From: John Lawson
Sent: 15/08/2023 12:34:45 PM
To: Council Northernbeaches Mailbox
Subject: DA2023/1023 - 32 Loblay Crescent Bilgola Plateau - Submission Opposing the Development Application
Attachments: Photo 10 bdry sstone steps rock face intersection.jpg; Photo 11 Rear Verbannum trees string - -wall boundary.jpg; Photo 12 - Existing garden lin #34 looking to #32.jpg; Photo 1 Front Lilli Piily - existing walls gfront v boundary.jpg; Photo 2 bdry line Verbannum trees locations.jpg; Photo 3 tree1 -wall intersection.jpg; Photo 4 Tree1 with flock of birds.jpg; Photo 5 west ffront exist walls v boundary stake & height walls.jpg; Photo 6 frnt retaining wall gas meter.jpg; Photo 7 our sandstone wall - fence locatioin.jpg; Photo 8 Bdry on top of SStone Wall.jpg; Photo 9 fence rock outcrop bdry interscetion.jpg; Tree Lopping Invoice INV-0725 (1).pdf; DA-02 Revised.pdf; D03 - Revised.pdf; DA-01 Revised.pdf; Sketch Section at Start SStone Steps.pdf; SUBMISSION IN REGARD TO DA20231023 - 32 Lobaly Cresc. Bilgola Plateau.pdf; Access to Neighbouring Land Agreement3 JL.pdf;

SUBMISSION IN REGARD TO DA/2023/1023 - 32 LOBLAY CRESCENT BILGOLA PLATEAU

Description: Alterations and additions to a dwe

RW DA-02

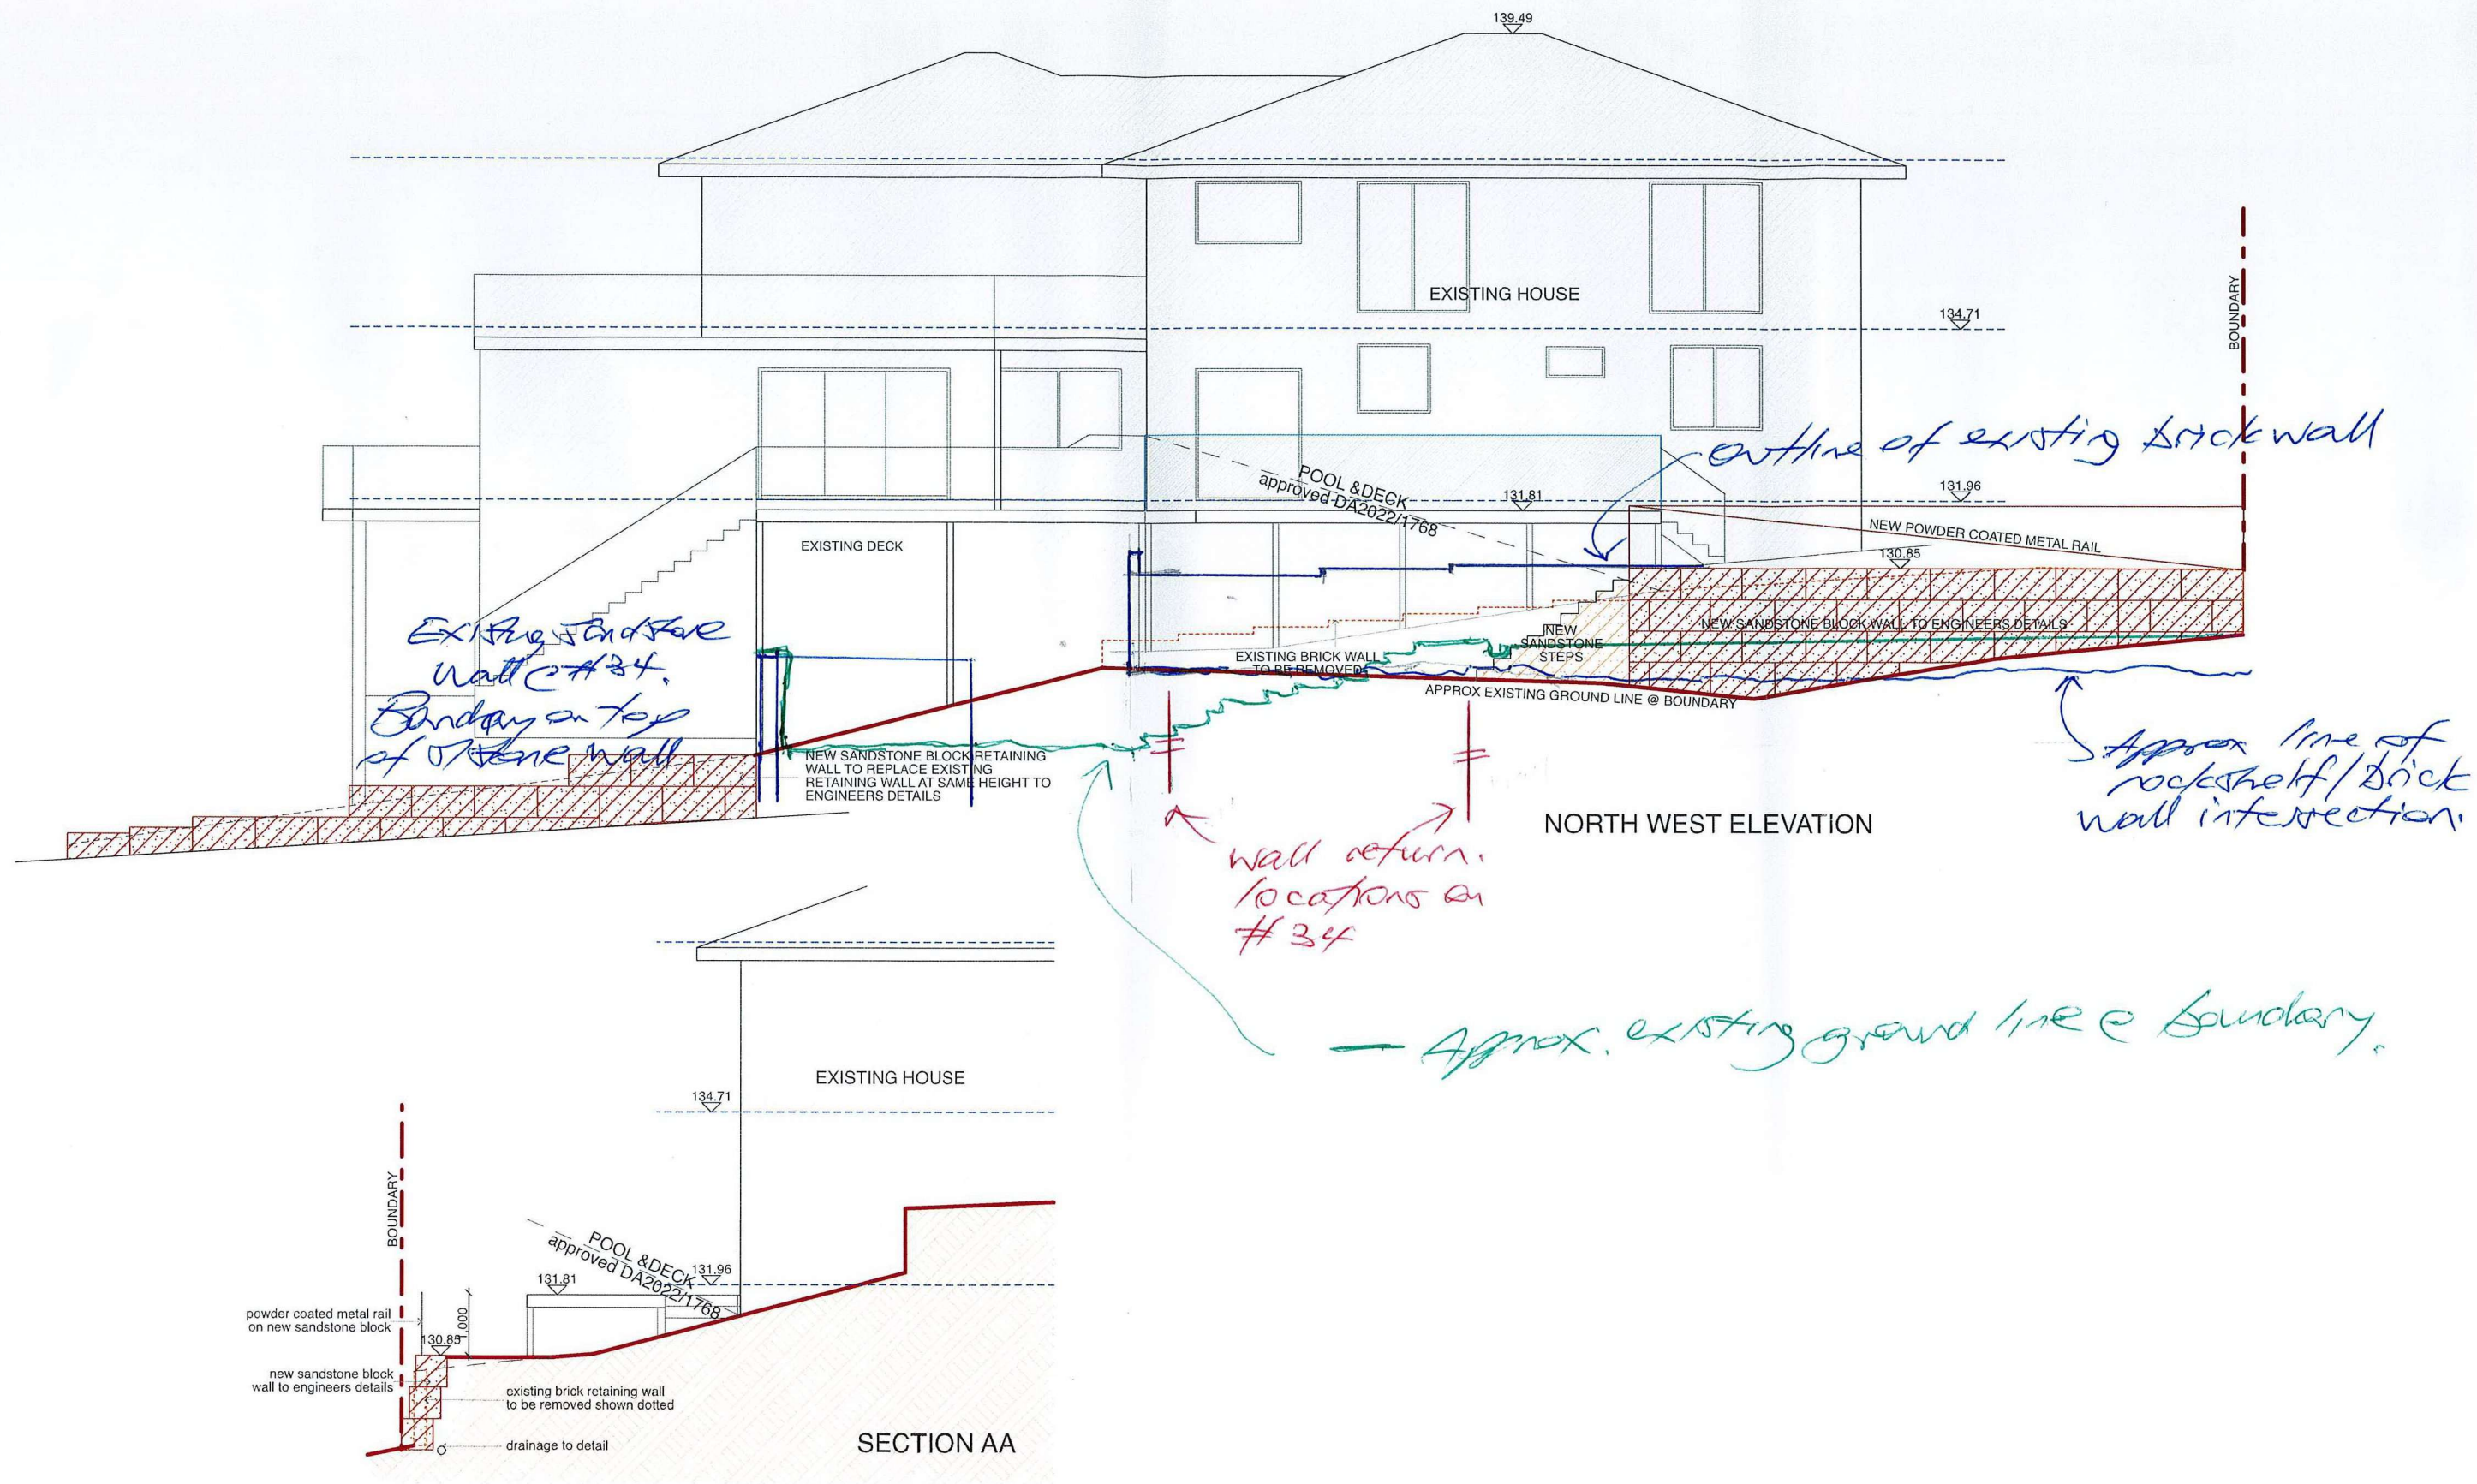
Regarding privacy issues, I note that it is not true that we are unaffected. The proposed stairs on the boundary will enable views into our rear 2nd & 3rd bedrooms. – pls see the attached revised Dwg. DA-02 for information on their location and relevance to our home when the correct dimensions / locations are shown on the plans

I further note that these stairs if considered part of a building line as drawn in DA-02 will have a zero setback from the boundary line.

- It is noted on Dwg. DA-02 that it is stated that the proposed timber fence will be a "1.8m high timber paling fence on existing rock."
- I note that our existing Sandstone Retaining Wall (see Photo #7) exists in this location due to the replacement of an original defective retaining wall approximately 18 years ago in accordance with a verbal agreement with the previous owner of #32. We built this wall at our cost to improve the amenity of our home and to rectify issues with this then defective retaining wall to hold back soil from falling into our property from #32.

Revised 12-8-23

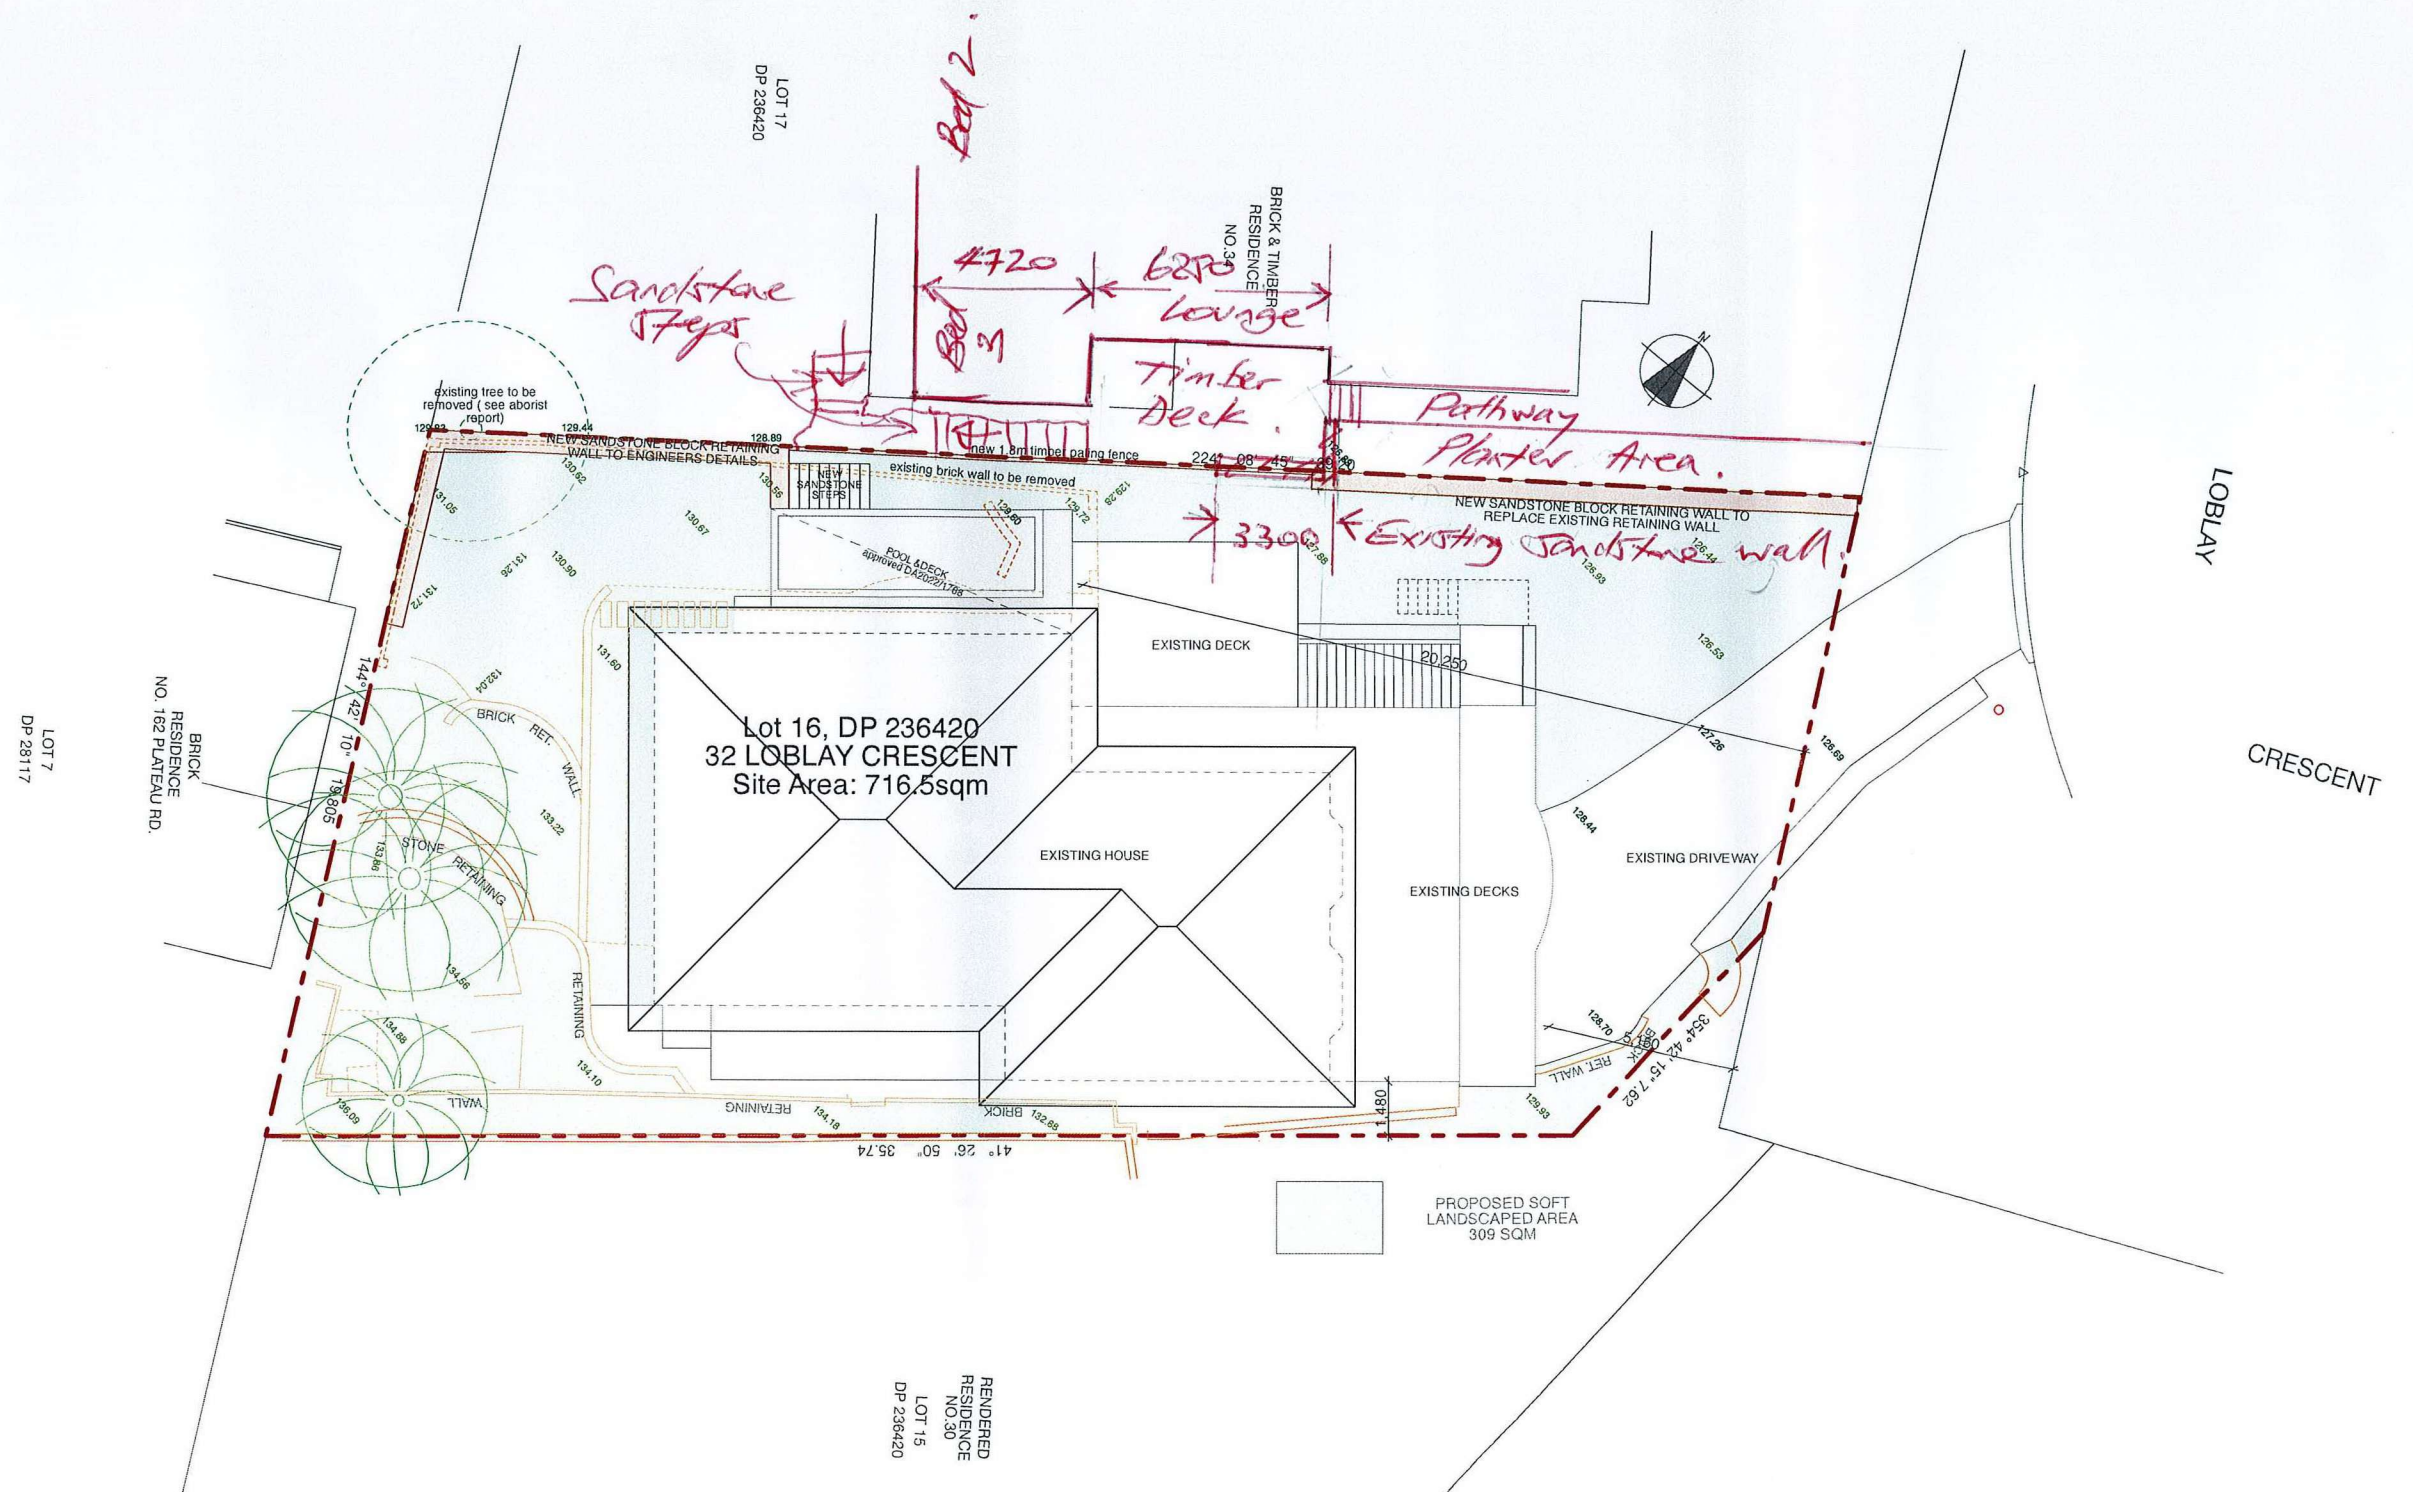
The drawing shows the approx. existing ground line at the boundary – it is incorrect. The height differences shown on the Elevation are much less than in reality and have relevance in terms of the fence height datum and in relation to our existing Sandstone retaining wall that is to have a 1.8m fence built on top of it at the boundary as per the application.

I have attached a revised Drawing DA-03 where I show the approx. actual boundary ground level. This Drawing shows measurements taken at the site based on the locations where the applicant has placed a string line along the boundary.

- I note that I have revised Drawing DA-03 Elevation section to show the actual elevations / approx. dimensions involved / correct orientation of the existing brick retaining wall as well as our existing Sandstone wall and deck area.

Revised 12-8-23
